International Isotopes Fluorine Products, Inc.
(IIFP)

Fluorine Extraction Process &
Depleted Uranium De-conversion
Plant (FEP/DUP)

**Request for Additional
Information to the
Environmental Report**

Revision A

Figure 4- 19 Residences Within Four-Mile Radius Around IIFP Site

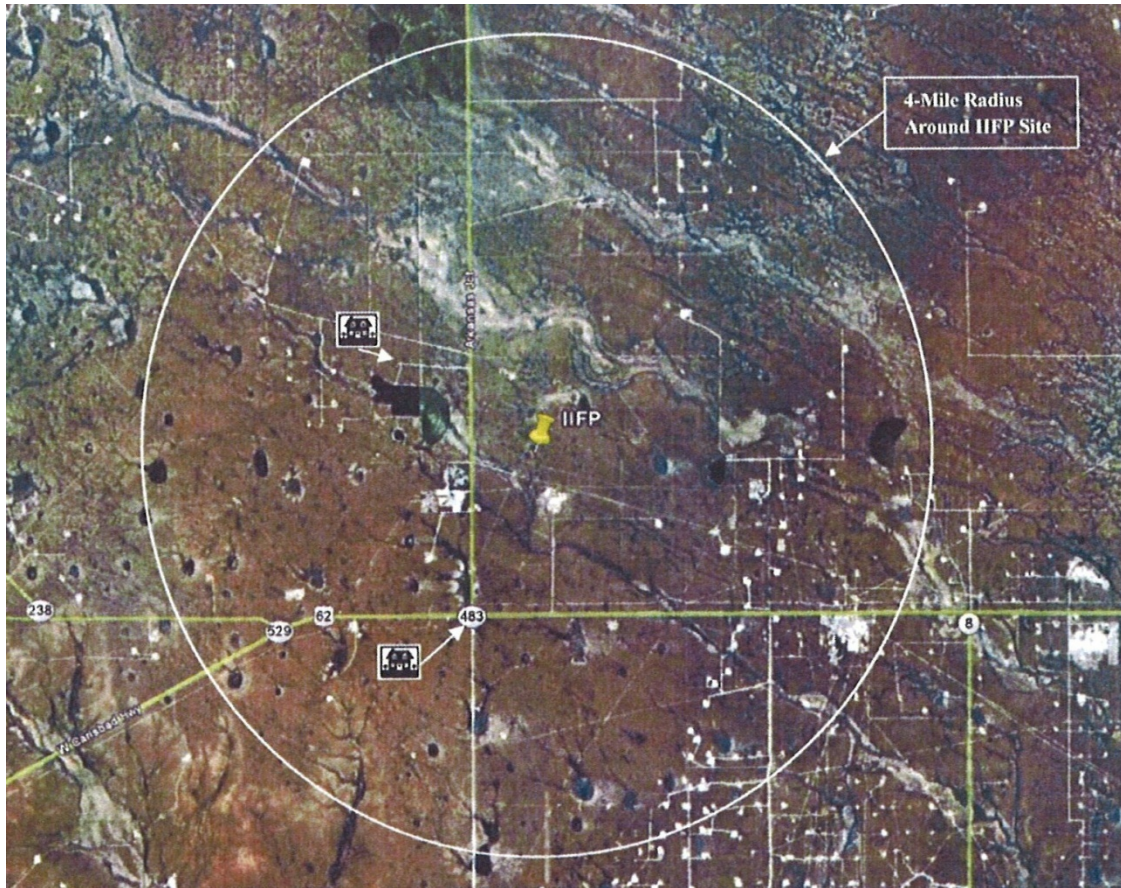
4.11.4.1 Residences within Four-Mile Radius of the Site (New Section added.)

When determining the area for impact assessment for a facility located outside the city limits or in a rural area, a 6.4-km (4-mi) radius [130 km² (50 mi²)] can be used. Figure 4-19 shows that area of impact around the IIFP Site. That same area of impact involves two census tracts as shown in Figure 4-20, Lea County Population, Census 2000 by Census Tract. One census tract (1100) has four (4) CBGs that have no disproportionate high minority or low-income populations within those CBGs. See Table C-1 in the Appendix. The other census tract (0700) has 6 CBGs. Table C-1 shows the percentage of persons in the following categories: Below Poverty Level, African American (Black), Indian, Asian, Other Race, Two or More Races, Hispanic, and Minorities. Of the various categories within those 6 block groups, only one category has a disproportionate high percentage [54.2% for minorities (Racial Minorities plus White Hispanics)].

Figure 4-19 shows one residence 2.6 km (1.6 mi) west northwest of the IIFP Site in census tract 1100 with no disproportionate high minority/low income populations. There are two residences at the intersection of U.S. 62 and NM 483 (Arkansas Junction) in census tract 0700, neither of which are minorities.
